TECHNICAL NOTICE

BURNER MANIFOLD SEALING GASKETS

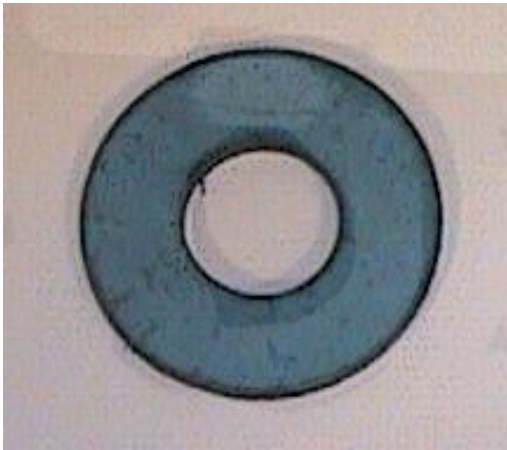
In a move to improve combustion equipment reliability BH-F will supply new viton gaskets in place of fibre washers on all new orders.

The fibre washer used to seal the burner pipe onto the burner manifold has sometimes failed to reseal when the manifold position is adjusted at the end of the forehearth warm-up.

The new viton material has been tested to ensure that, even after exposure to high temperatures, the gasket reseals successfully. During these tests it was found that much less clamping force is required to achieve a good seal.
